## Town of Montgomery Police Station

106 Bracken Road, Montgomery New York, 12549

### ADDENDUM #3: April 25, 2025

Drawing: DOORS & WINDOW SCHEDULE

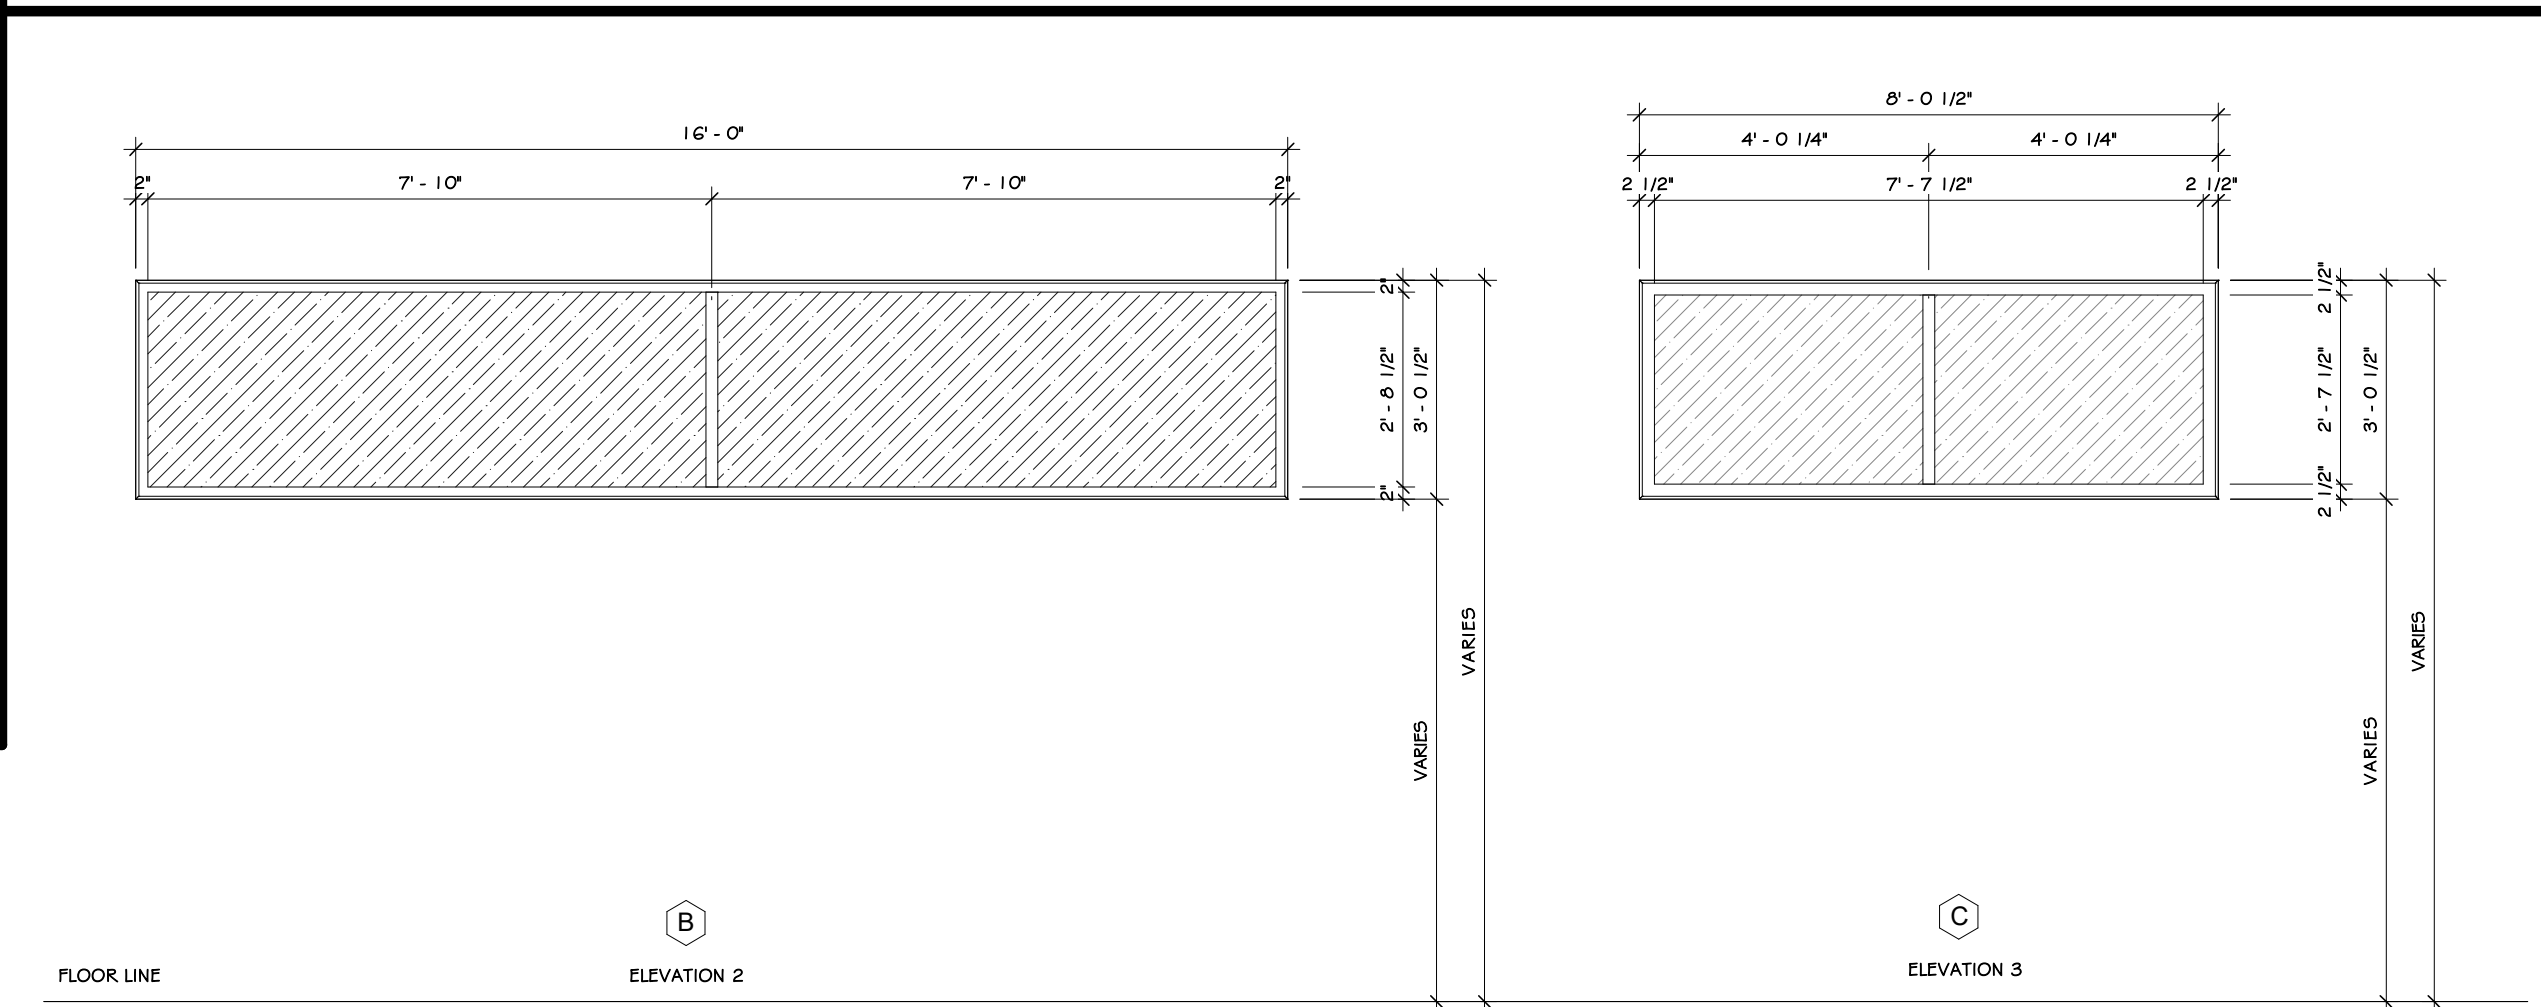
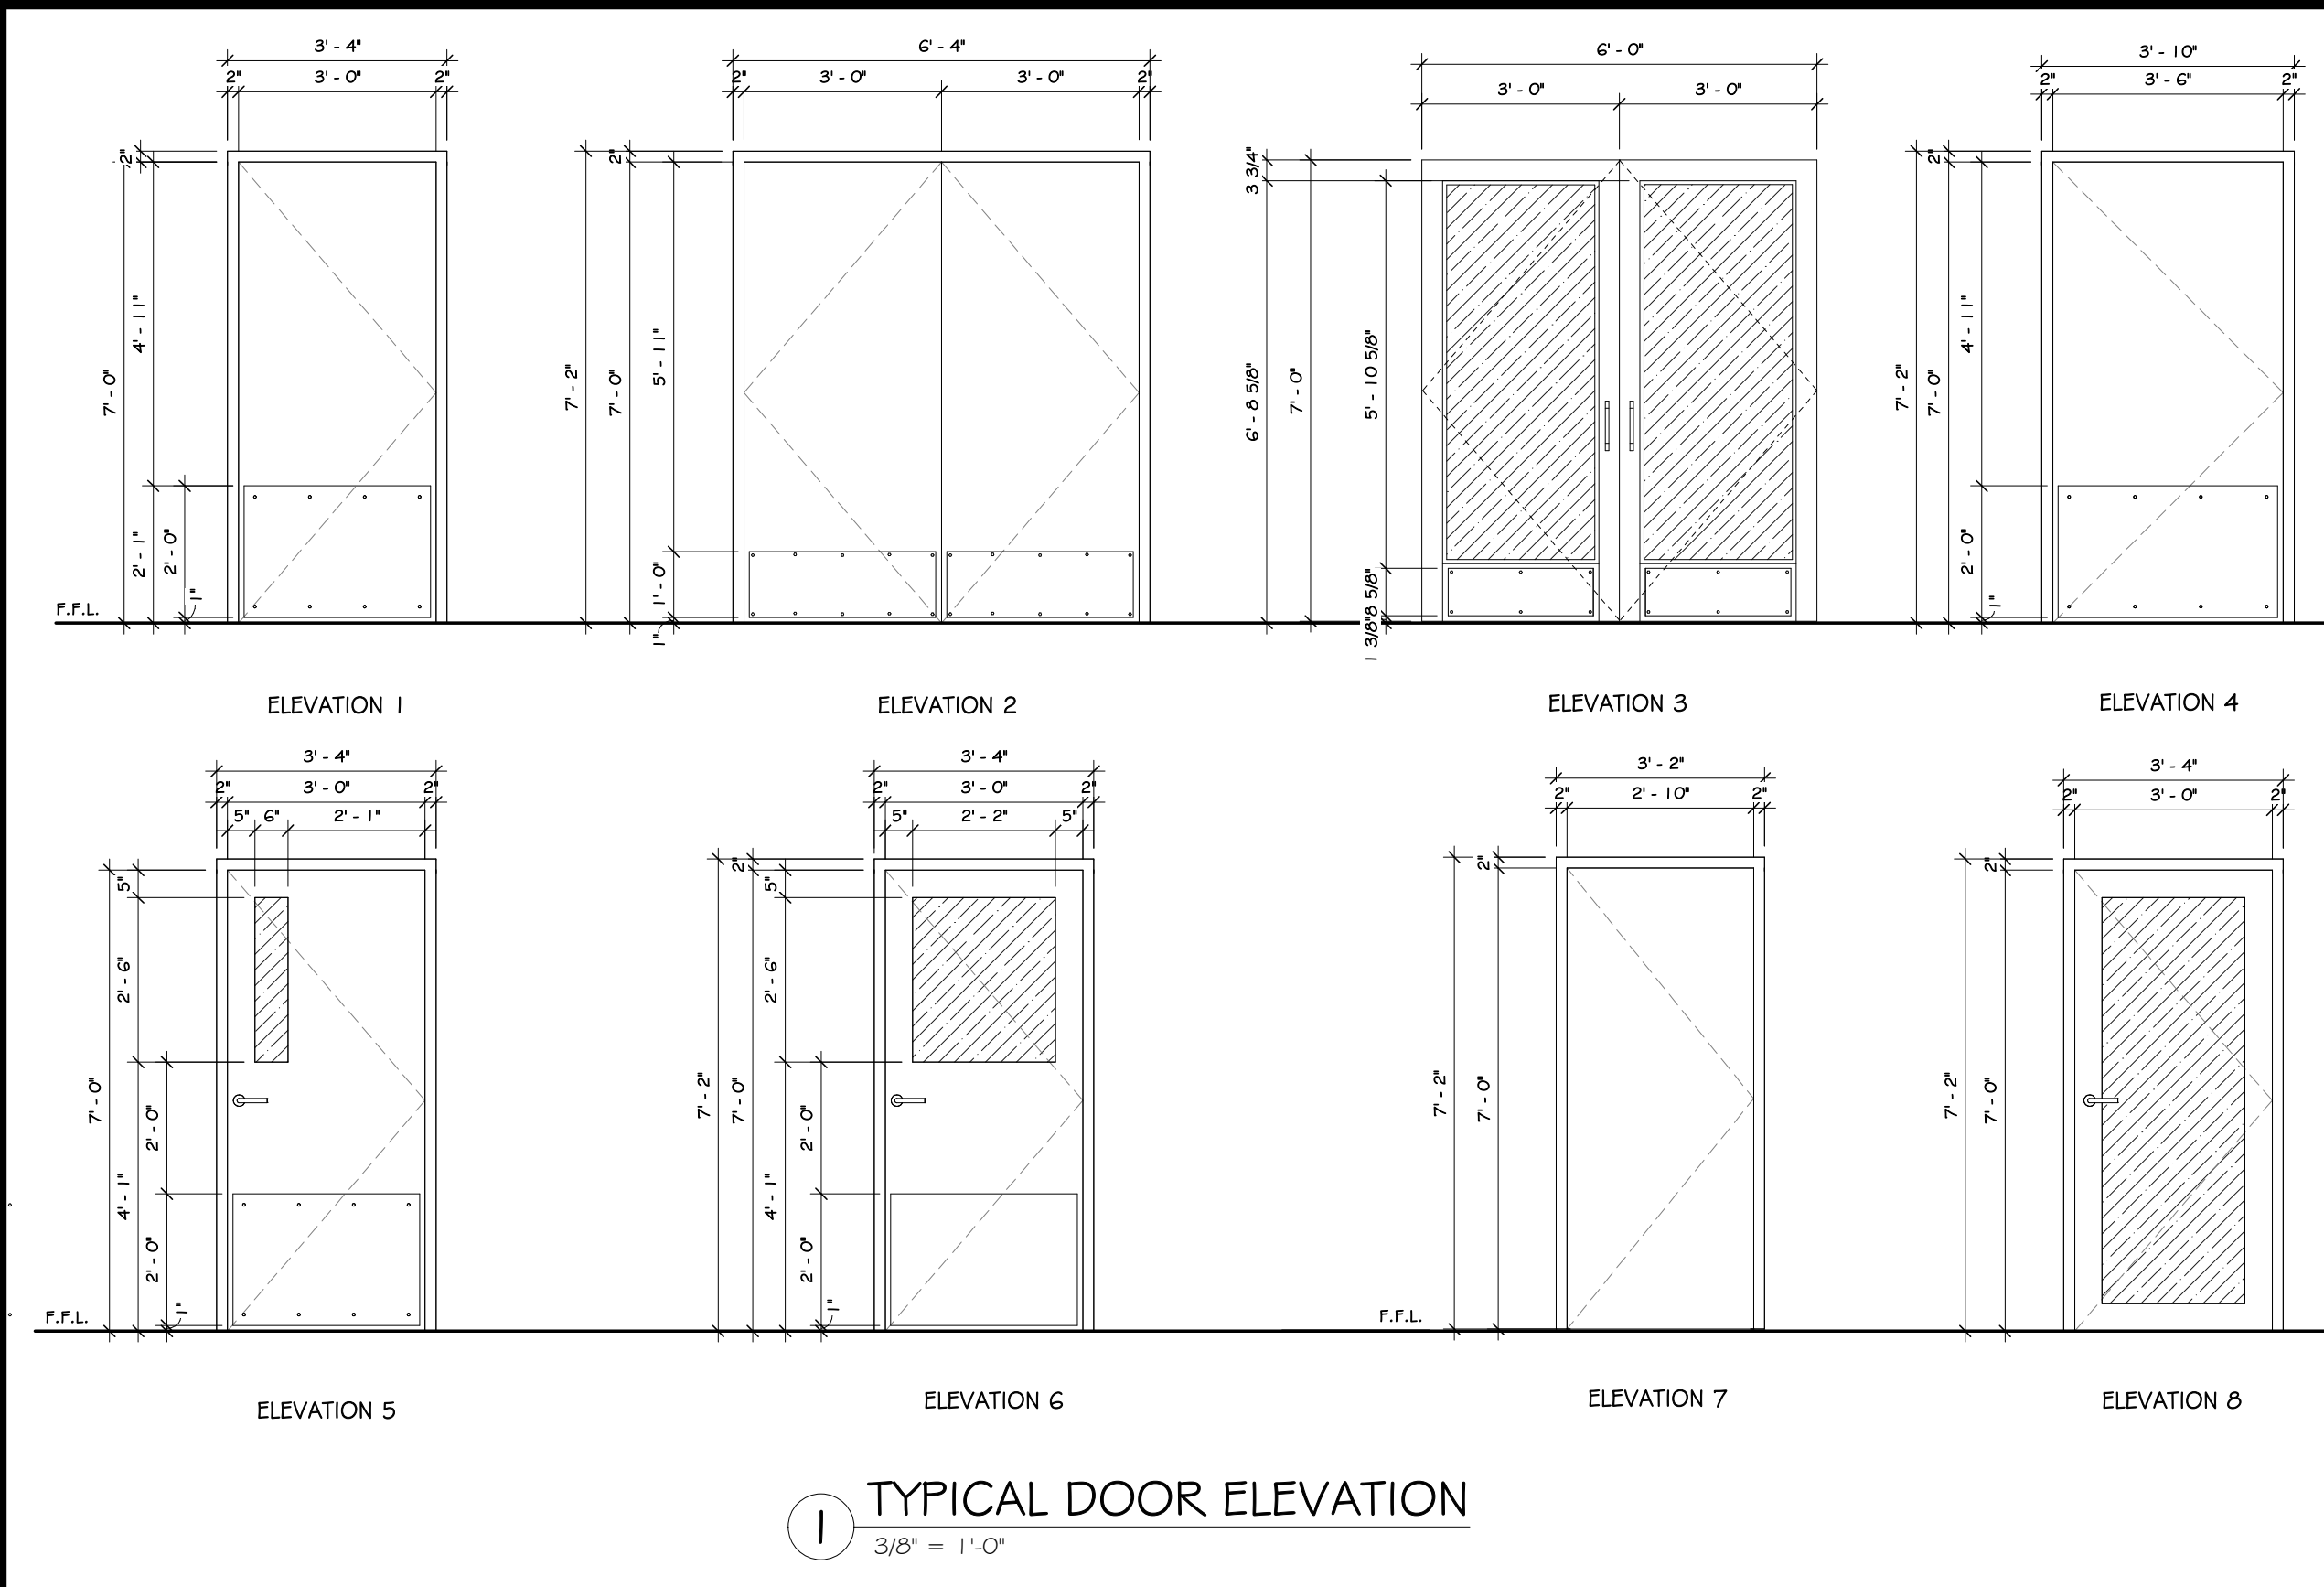
13. Drawing A-800 depicts Typical Door Elevations which are not keyed into the Door Schedule. Please advise.  
**RESPONSE:** Drawings A-800 has been revised and is attached to this addendum.

Question, there is no section 01 21 00 Allowances.  
**RESPONSE:** There are no allowances for this project.
40. Please clarify Door schedule on A-800 door type column.

**RESPONSE:** Drawings A-800 has been revised to clarify the door elevation numbers.
41. Details 1 & 2/A-608 appear to show horizontal sliding windows. Please confirm all windows on the project are fixed.

EROSION AND SEDIMENT CONTROL PLAN			
PREPARED FOR			
<b>NEW POLICE FACILITY</b> <b>(TOWN OF MONTGOMERY)</b>		TOWN OF MONTGOMERY ORANGE COUNTY, NEW YORK	
		Drawn By: PLS Checked By: Scale: 1" = 20' Tax Map No.: 30-1-87 Drawing No.: C30 A- 18 - 2309 - 01

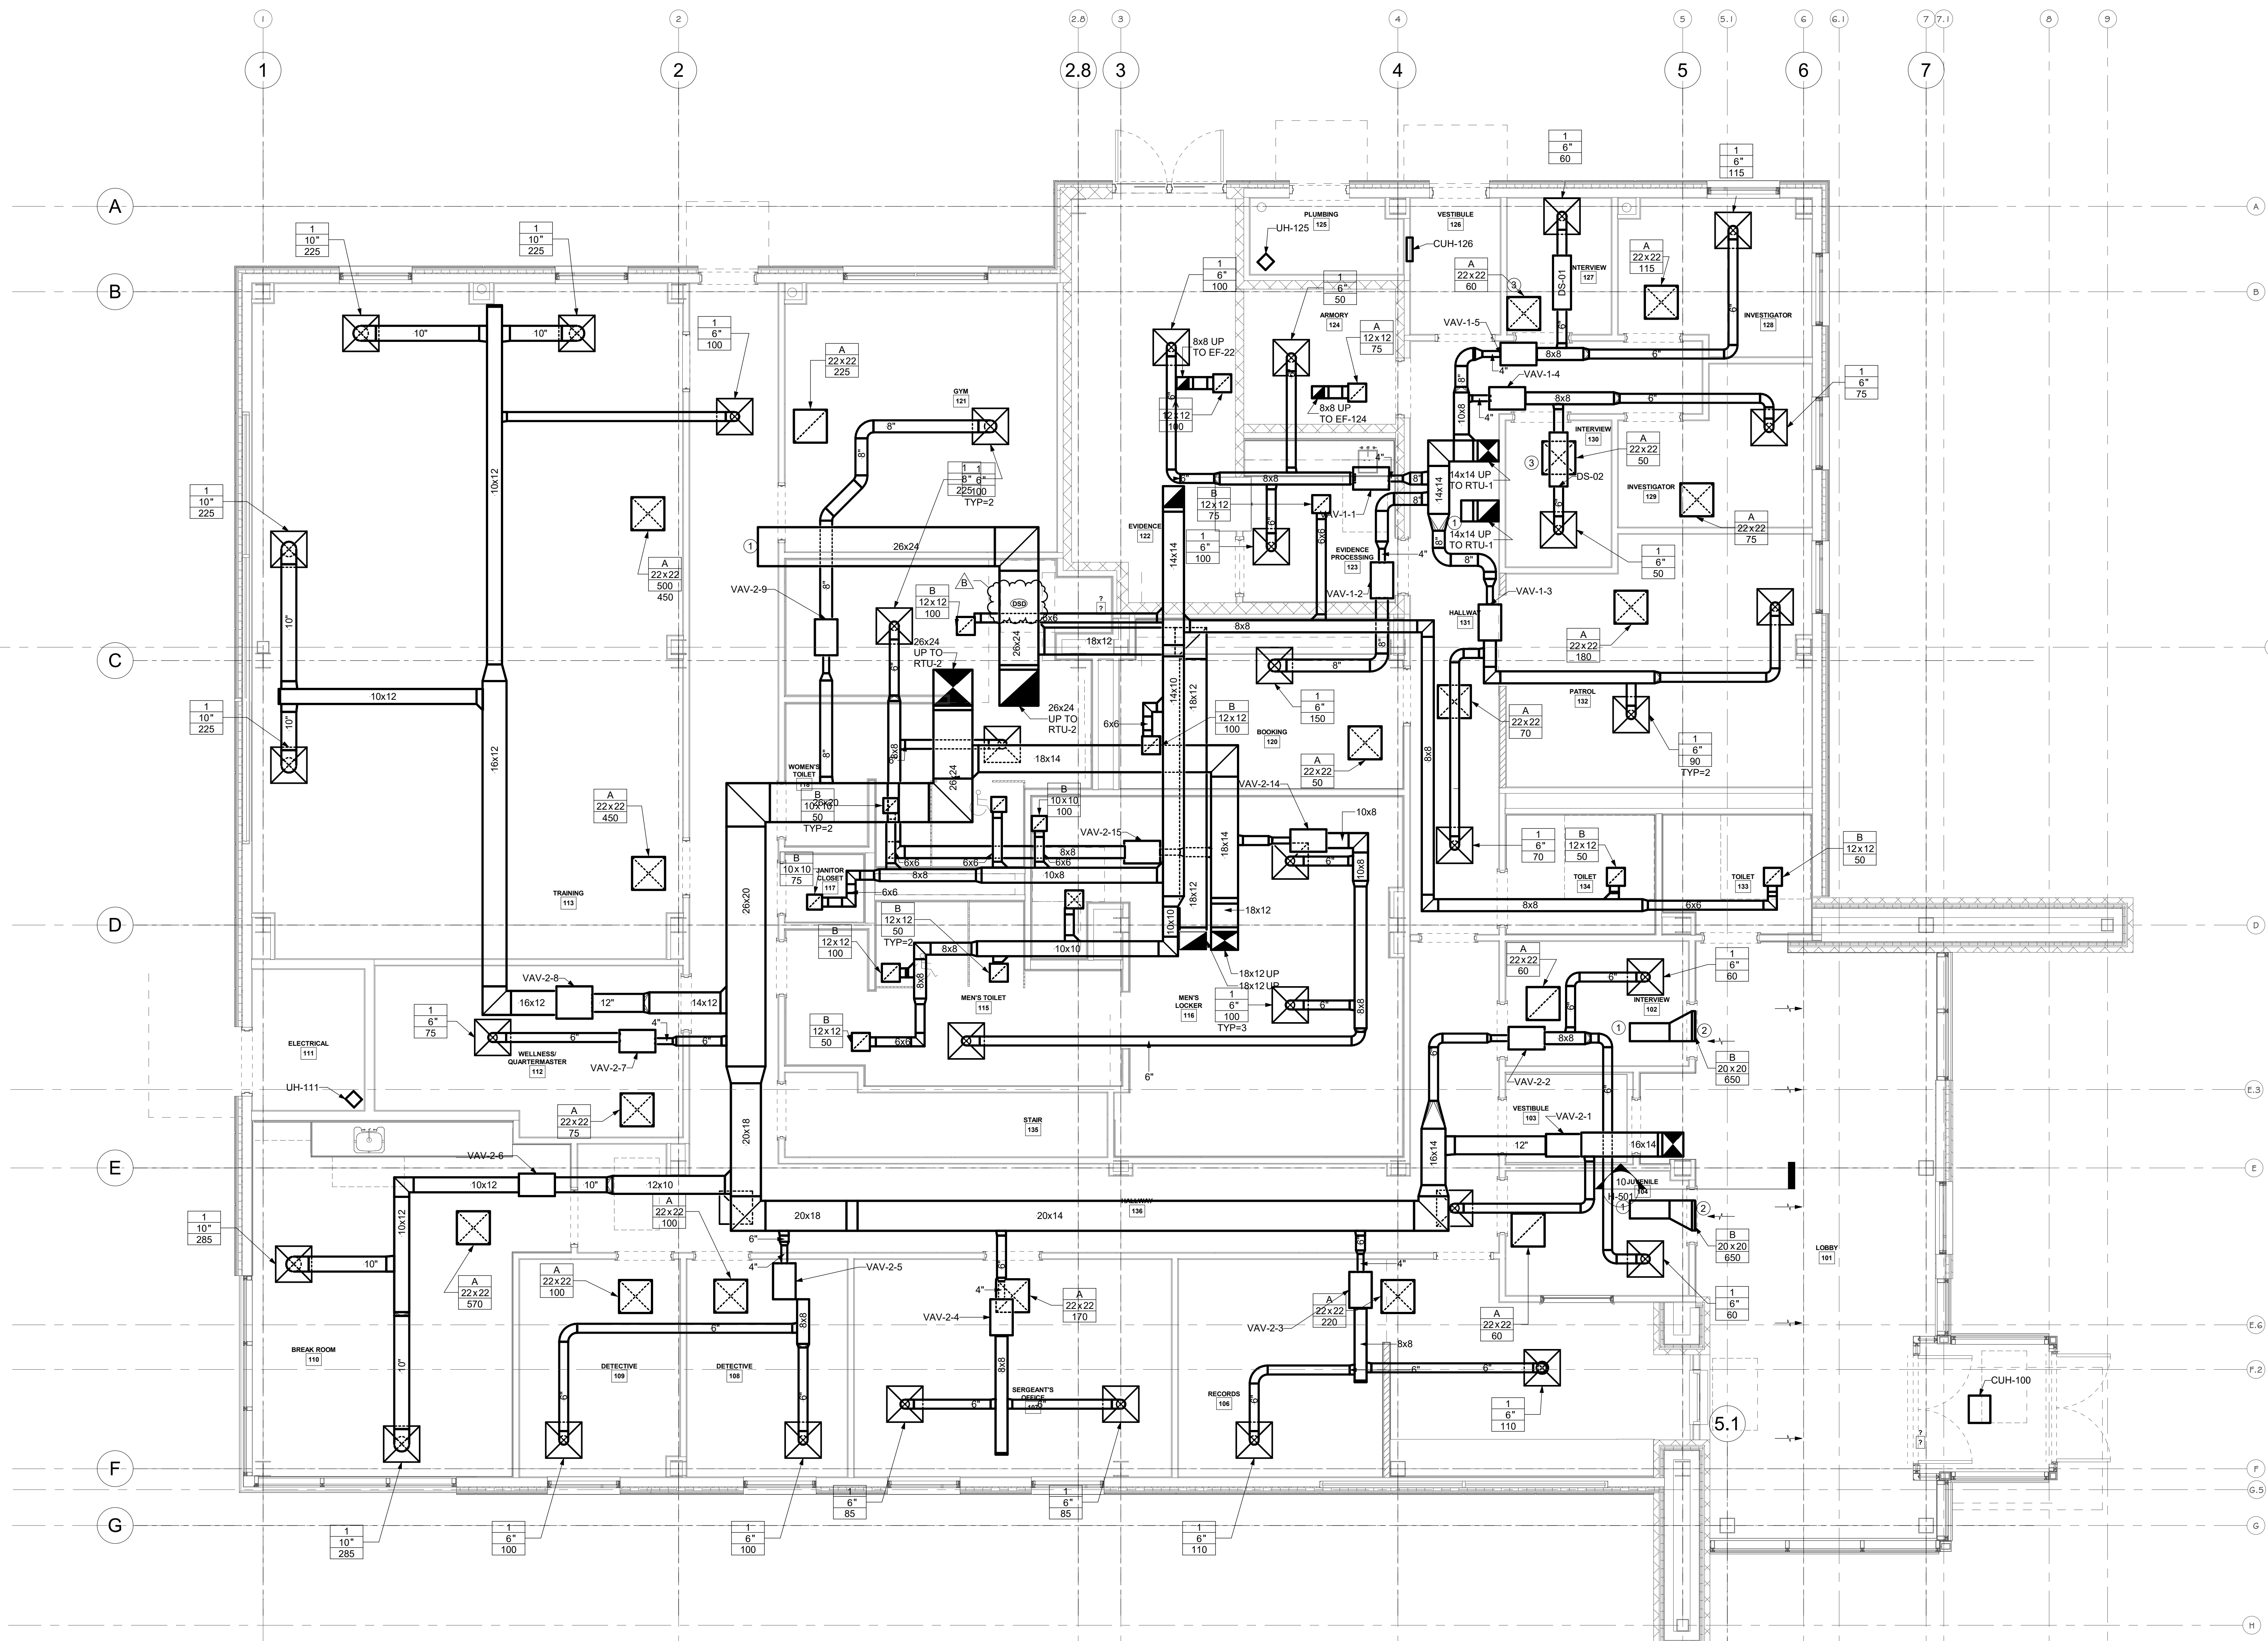
18. Please identify locations of Wood Guard Rail detailed on C3D Construction Details 2.  
**RESPONSE:** The civil drawings have been updated to include additional guard rail details. The updated civil drawings are attached to this addendum.

6. **As a notification**, civil drawings 2 of 6 – Site Plan, 3 of 6 – Grading, Utility, and Lighting Plan, and 4 of 6 – Erosion and Sediment Control Plan have been updated to include additional information on the guard rail and chain link fence clarification. Additionally, the scales on the grading/utility plans have been updated.
